**CITY OF WINTER PARK  
PLANNING AND ZONING BOARD**

**Staff Report  
January 8, 2013**

**REQUEST OF LAKESIDE WINTER PARK LLC FOR:** CONDITIONAL USE APPROVAL TO CONSTRUCT 35,500 SQUARE FEET OF RETAIL, RESTAURANT AND OFFICE BUILDING SPACE ON THE PROPERTIES AT 111 AND 131 N. ORLANDO AVENUE, ZONED C-3. THE CONDITIONAL USES INCLUDE THE PROJECT SIZE; DRIVE-IN TELLERS FOR A PROPOSED BRANCH BANK AND RESTAURANTS WITH ALCOHOLIC BEVERAGE CONSUMPTION WITHIN 300 FEET OF RESIDENTIAL PROPERTIES.

## VARIANCES FOR LAKESIDE WINTER PARK

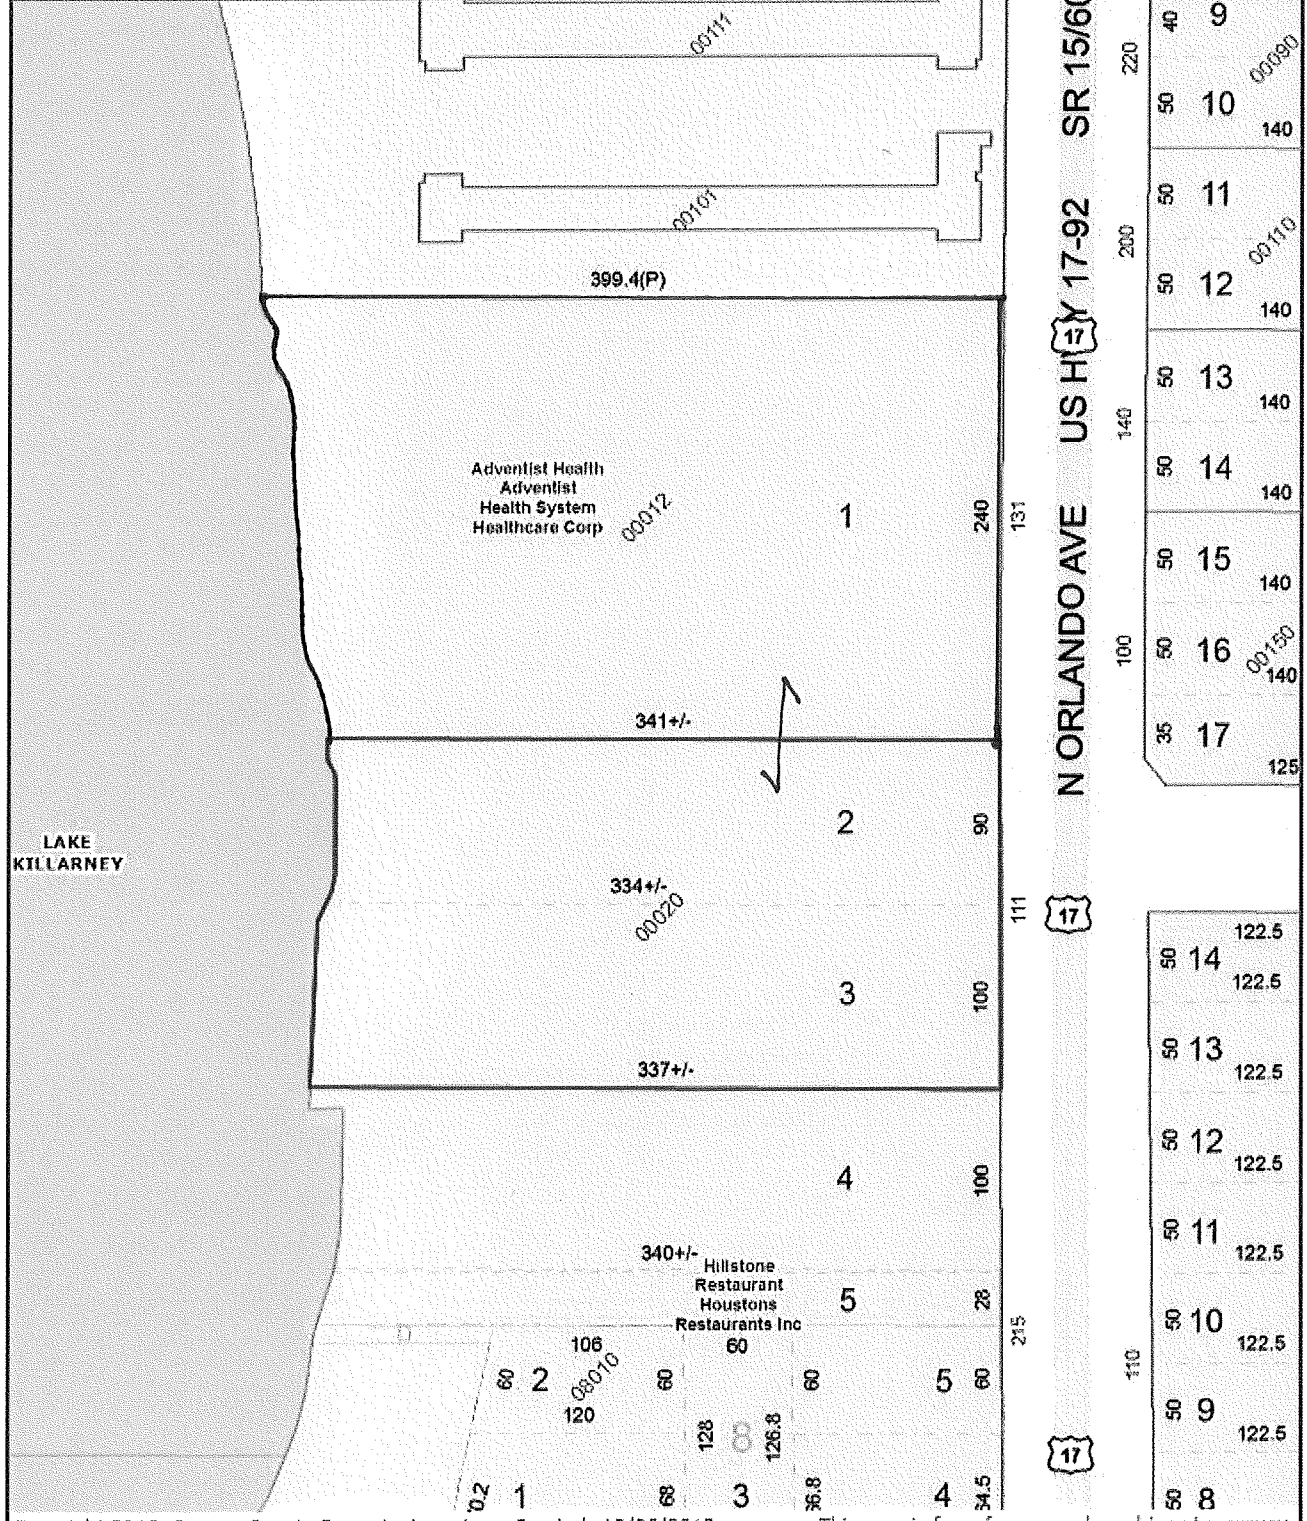
**Variance Requests:** The attached page details the eight variances requested. Primarily the variances relate to the relaxation of the landscape standards within the new parking lot. The desire for the variances is to increase the yield of parking spaces which increases the yield of leasable building area. Again, as long as everyone's expectations are for the look of a shopping center parking lot those variances are acceptable. There are two of the variances that the staff will recommend for denial:

1. **Lakefront Setback Variance:** The city code requires a 75 foot lakefront setback. Single family homes can be located at a 50 foot setback but multi-family of commercial building (because they are much larger) must adhere to a 75 foot setback. The rationale presented by the applicant is that the closer proximity allows a greater pedestrian boardwalk amenity. The staff believes that one can design a pedestrian friendly lakefront environment in 75 feet of setback or in 50 feet of setback. However, if the buildings can be closer to the water at a 50 foot setback then the parking lot can be larger. If the variance is denied the site plan (based on the current design) loses 27 parking spaces and thus 6,750 sq. ft. of building area. The staff's concerns for this lakefront variance are based in part upon the existing setbacks of the Lake Killarney Condominiums (85 feet) and the Hillstone/Houston's restaurant (100 feet). The proposed 50 foot lakefront setback variance will impair more of the traditional lake views from the Lake Killarney Condominiums. It also creates a view scenario on the lakefront patio at Hillstone/Houston's where you will be looking at the unattractive end wall of this project. Together with the design challenges faced with the all the storm water retention fitting in the 50 feet and needing to preserve the lakefront cypress trees this project should meet the 75 foot lakefront setback per code.

2. **Parking Variance:** Restaurant parking is based on one space for each three seats. This is similar to that used by other cities. It in fact does not provide the 'real world' parking that successful restaurants need but is based on a 60-70% occupancy factor.

This project with one restaurant of (3,500 sq. ft. & 150 seats) needs a variance of 20 parking spaces. This project with two restaurants (6,000 sq. ft. and 270 seats) needs a variance of 50 parking spaces. Staff agrees with the applicant that there is some small amount of parking "float" between the various tenants. However, if the "specialty" grocer is as popular as we expect then the parking lot will have no "float". It is the second restaurant that creates the need for the parking variance and will create problems for the users. The variance request in simple terms is to have a second restaurant with no parking provided for it. The Winter Park Village has been the most celebrated redevelopment project in the City and the most criticized, only because of the lack of parking. Staff does not want to make the same mistake again. The number one concern of the residents of the lake Killarney Condominiums is noise from the second restaurant near door to their units. The solution is to eliminate the second (northern) restaurant and to provide a lesser parking variance of 20 spaces to allow the primary (3,500 sq. ft. - 150 seat) restaurant only.

**STAFF RECOMMENDATION IS FOR APPROVAL OF THE "PRELIMINARY" CONDITIONAL USE subject to the following conditions:**

- 1. That the project is limited to one restaurant located in the southern building with a maximum of 150 seats and thus limiting the parking variance to 20 spaces and that no indoor or outdoor amplified musical entertainment is permitted after 10:00 pm**

- 2. That the northern building conform to the code required 75 foot lakefront setback and that the southern building also comply unless consent is granted by the Hillstone restaurant.**
